OIA IRO-363

Official information request – Follow up to OIA IRO-339 – Resource Consent Application.

Date: 01 August 2022 updated 12 August 2022, **final 24 August 2022**
SR510418 – Jervois Quay
WCC Planner - Angela Jones

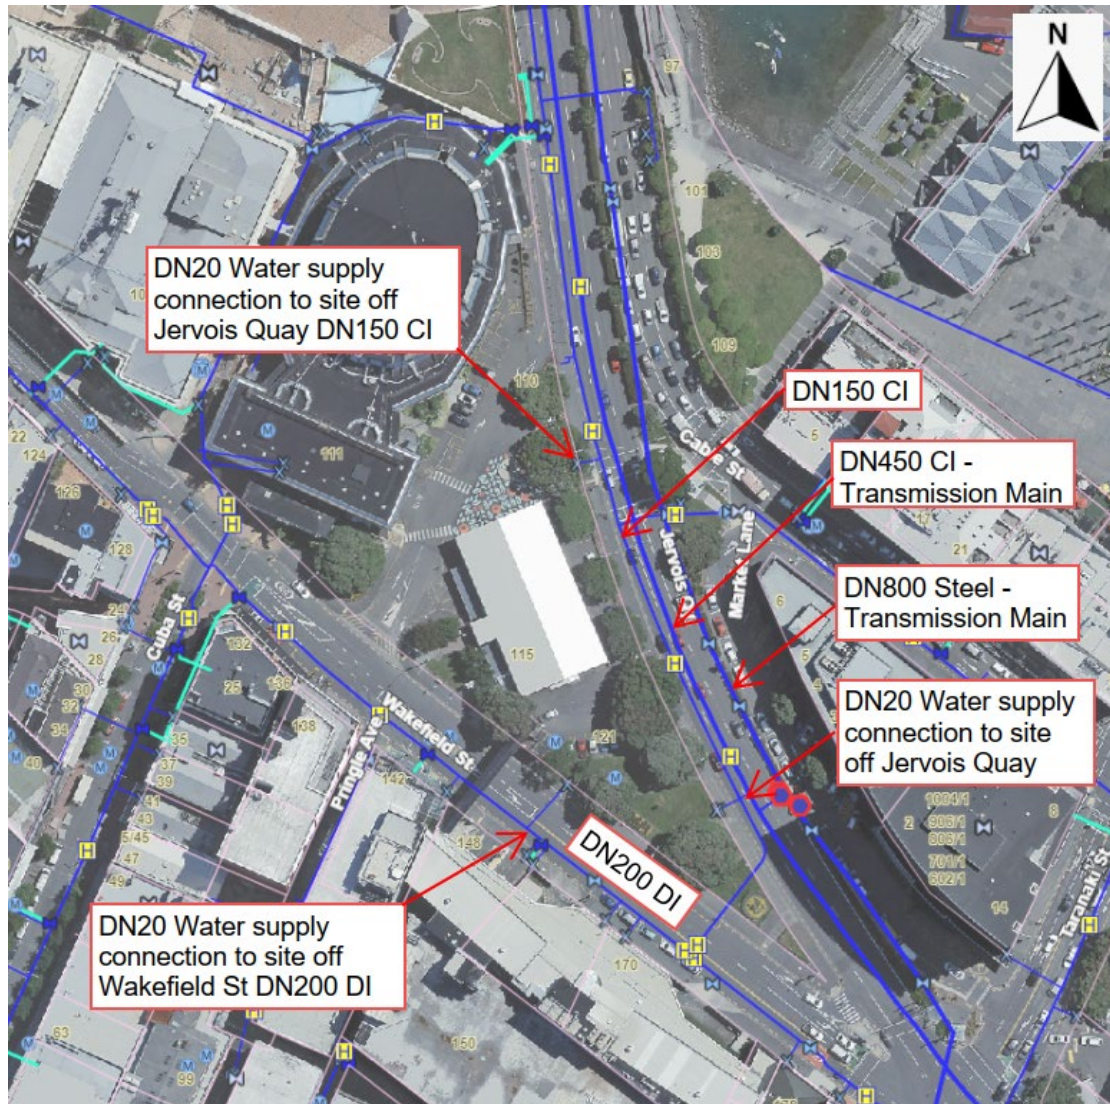
- Jervois Quay DN150 Cast Iron watermain
- Wakefield Street DN200 Ductile Iron watermain

The applicant claims there is an existing DN40 water supply from the DN200 DI Wakefield watermain which services the existing Royal NZ Ballet building. This service is not shown on Council Records nor are As-Built records provided to prove this connection.

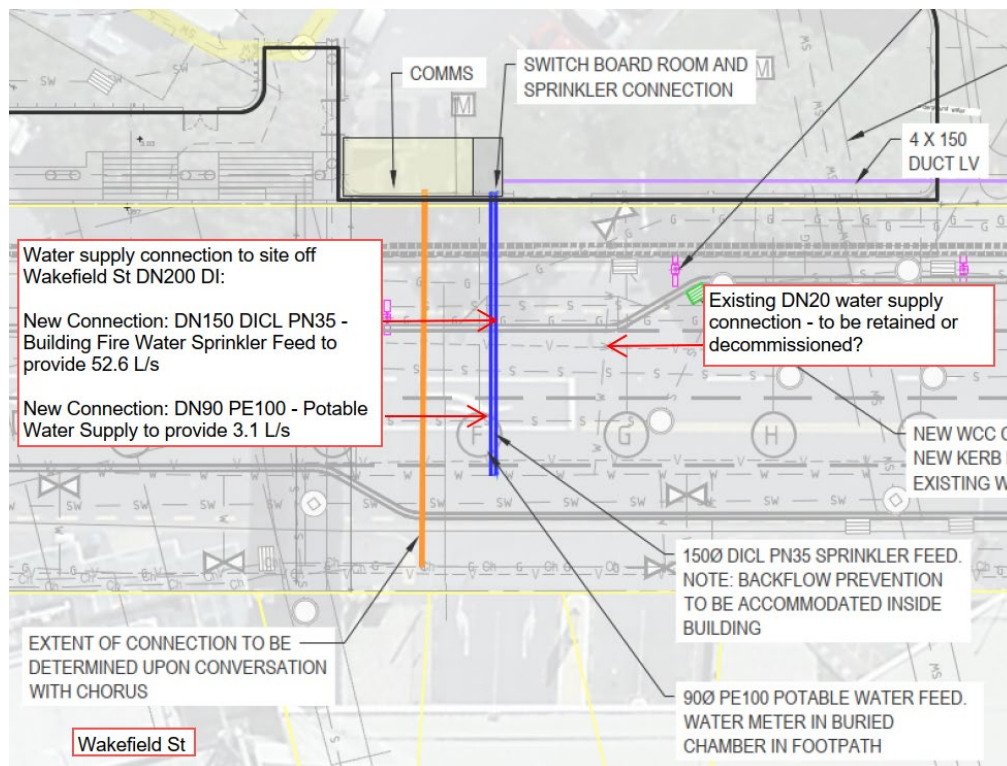
The applicant has indicated on their drawing (520408-0000-DRG-CC-0010-A) that they intend to install 2 new connections into the Wakefield Street DN200 DI watermain in order to service the development:

- DN150 DI CL PN35 – Building Fire Water Sprinkler Feed
- DN90 PE100 Potable Water Supply

These 2 no. new connections appear to be near the location of the existing DN20 water supply connection off the DN200 DI Wakefield Street watermain. The existing connections are not suitable for re-use and will need to be abandoned.

The WWL modelling team have indicated that there is 75-80 m of pressure in the water supply network at the point connection into the DN200 DI Wakefield Street watermain. This modelling result is based on a 2018 model which does not factor in future and proposed and developments. The applicant has advised a fire demand of 52.6 L/s and a domestic flow of 3.1 L/s. Calculations are required to support the assessment and demonstrate that this can be achieved from the public network.

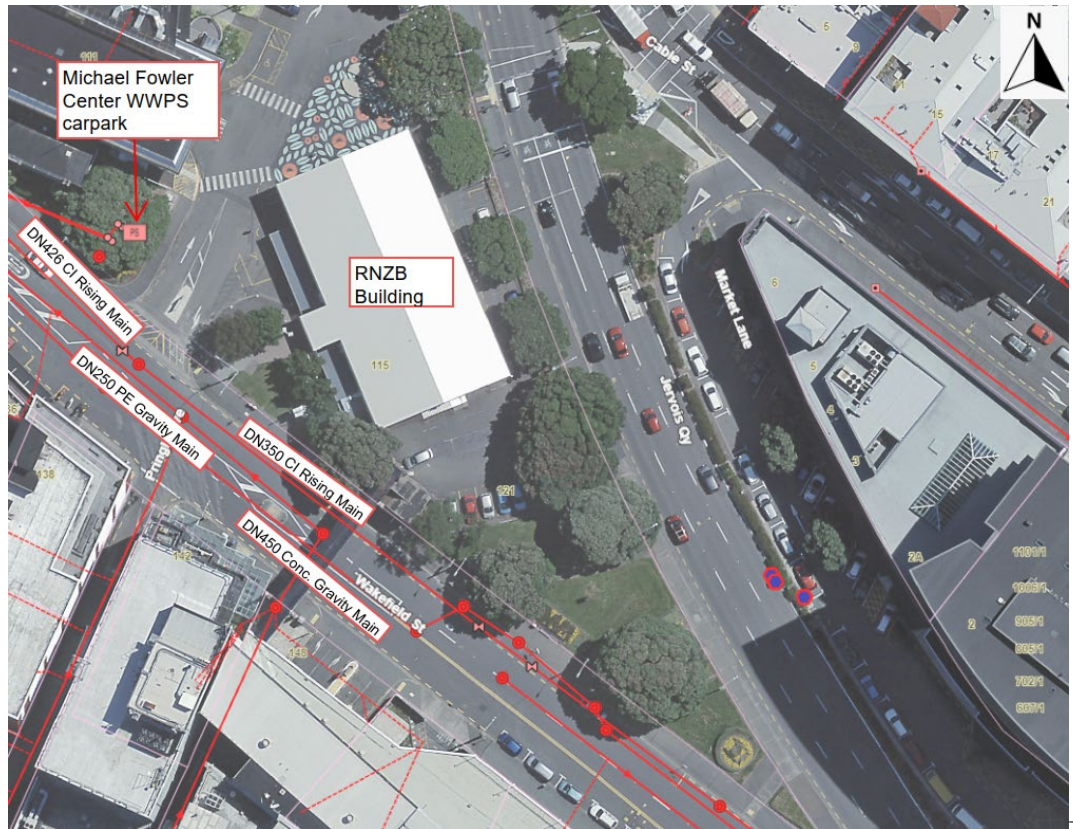
There are numerous wastewater pipes along Wakefield Street.

The applicant indicates that there is an existing WW service lateral which services the RNZB building (DN unknown). The applicant's drawing suggests that this service lateral connects directly in to the existing DN350 CI Rising main on Wakefield Street although, their reporting and labels indicate they have mistaken this to the DN450 Gravity main.

The applicant has indicated that there is an existing WW storage tank onsite. This tank is adjacent to the RNZB building and is beneath a road accessway. The tank provides storage for the adjacent WWPS located in the MFC car park and is a public wastewater asset. WWL have met with the applicant (22 June 2022) and, following receipt of a preliminary seismic assessment and a structural assessment have agreed a build over of the storage tank.

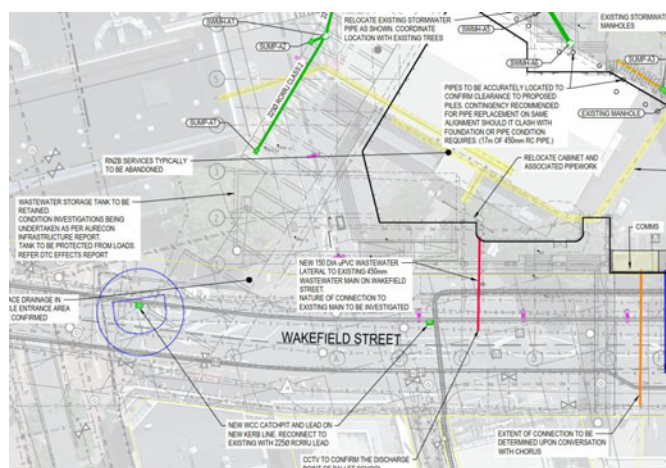
- Tank generally compliant with current codes + sea-level rise + potential hazard changes.
- The base of the tank is adequately socketed into the underlying alluviums (below potential liquefaction) to prevent lateral displacement of the tank.

- Unbalanced, seismically induced lateral earth pressures may result in minor settlements (50-100mm) across (or along) the tank. This could result in a small tilt (approx. 0.5 degrees max).

- Tank displacements minimal, proposed pile clearances are satisfactory.
- Flexural demands on tank due to passive soil pressures and pile reactions (for a 1-in-1000 year event) are well within existing tank capacity.

- It is apparent that original design allowed for worst case buoyancy (water at ground level).
- Removal of overburden at eastern end of tank (where proposed to build over) may reduce factors of safety below minimum. Anchor piles or ballast may be required.

At detailed design the design must ensure:

- 24/7 access to the tank for heavy vehicles must be maintained at all times.
- WWL need to be able to safely undertake long term repairs / refurbishment / renewal. An easement should be granted in favour of WCC to ensure the access.
- The building tenants recognise that this a critical infrastructure item which is prone to noisy / smelly maintenance from time to time.

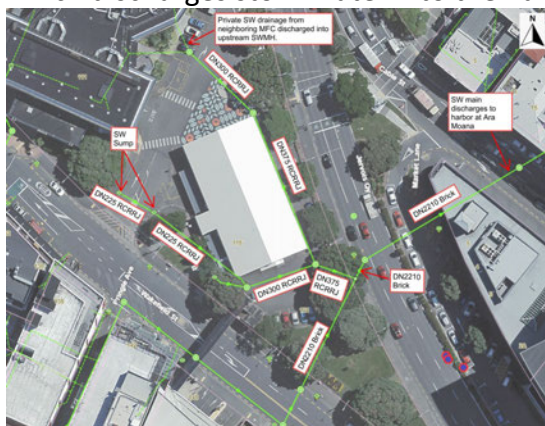
The SW infrastructure onsite comprises a series of sumps, pipes and mh's which ultimately drain into the 2210mm wide x 1220mm high ovoid stormwater main which discharges stormwater into the harbor at the location of the Ara Moana.

The applicant undertook to complete a CCTV inspection of the 2210mm x 1220mm ovoid stormwater main. CCTV footage confirms this pipe is ovoid in shape, is

constructed from concrete and indicates the pipe is showing signs of ageing but is still in serviceable.

WWL have confirmed (email correspondence, Samir Hermiz) that the existing ovoid stormwater main is at and over design capacity during peak stormwater events and need to remain accessible for upgrade / repair.

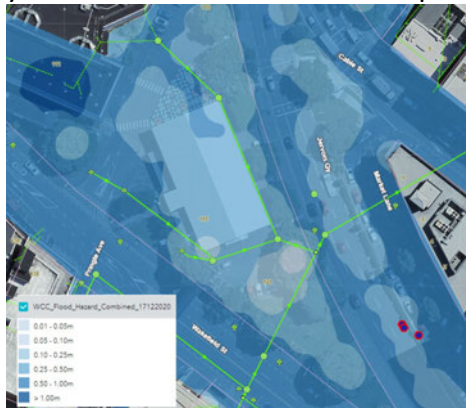
WWL flood maps indicate that the site is at risk of flood (0.01 – 0.5m) during 1/100 year flood events. The flood maps indicate the flooding varies across the site.

The applicant has undertaken some initial flood risk assessment (Aurecon). Simulations were run for 1/100 ARI event with allowance for the effects of climate change. Model results indicate:

- 20 mm increase for 10 year ARI + Climate change
- 30 mm increase for 100 year ARI + Climate change

These results indicate that most existing buildings in the area of the proposed development can be expected to flood in a 100yr ARI+CC event. The results have been demonstrated to be less than minor and as the flooding in this area is largely tidal it is not considered that further mitigation is required.

Model results confirm the proposed development floor levels to be marginally higher than the existing building. WWL confirmed with the applicant's result that based on modelling results the FFL of the development should be >3.03 m (200 mm above the RL of the 100yr+CC simulation model result of 2.83 m)

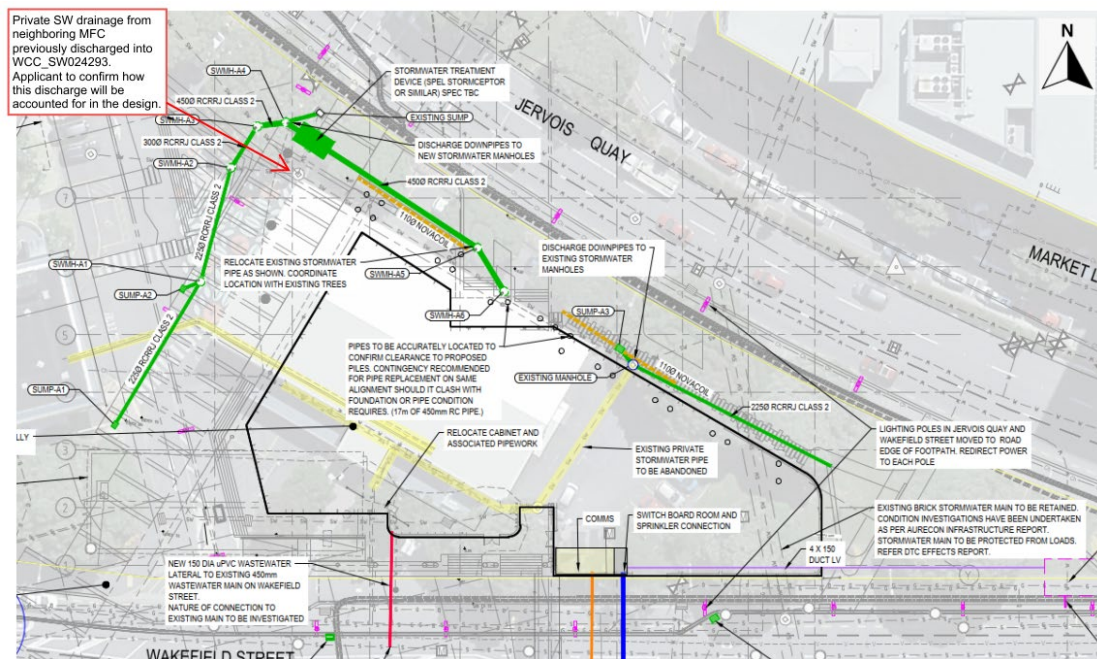
- The limited fetch length of approximately 10km, which is not expected to create waves large and powerful enough to reach the building.

- The extreme storm conditions are to coincide with MHWS and high tide window. The joint probability of occurrence reduces the likelihood of such an event.
- The large number of buildings and barriers to pass (i.e. Frank Kitts Park, Rowing Club, Wharewaka Building, lagoon, pedestrian overbridge, vegetation). These structures will cause the waves to break and diffract (curve around structures), which reduces the wave height.

This assessment is accepted and it is not considered necessary to increase the freeboard for potential wave action.

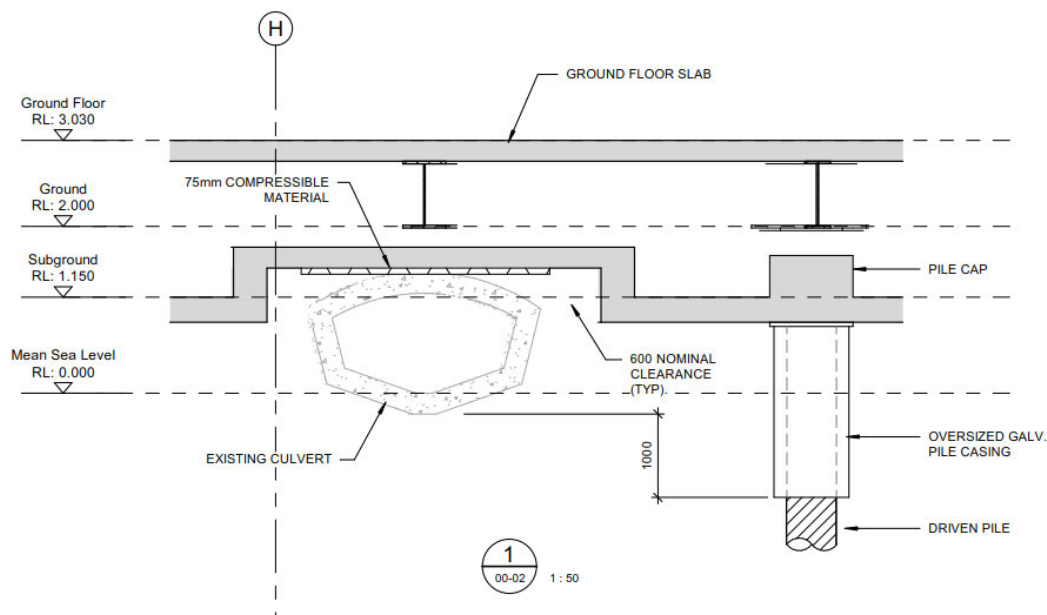
WWL have confirmed (email correspondence, Samir Hermiz) that construction over/replacement/rehabilitation of the the existing ovoid main requires specialist input and design. WWL confirm the downstream ovoid stormwater main is at full

capacity during SW events – SW neutrality or betterment for this development is required as a result.

The applicant is proposing to retain the existing ovoid stormwater main and has designed the building to allow long term maintenance access to be retained such that the main can be repaired in the future if required.

The ovoid pipe has an IL of approximately 0 m and with the building construction will be approximately 3 m below the ground floor slab. The Regional Specification for Water Services drawing DR09 any building above the main would need to be at least 4m above the proposed ground level (depth to IL + 1m). This would put the L1 cantilever at 7 m RL to the underside of the floor slab.

No planting will be accepted over the ovoid pipe.
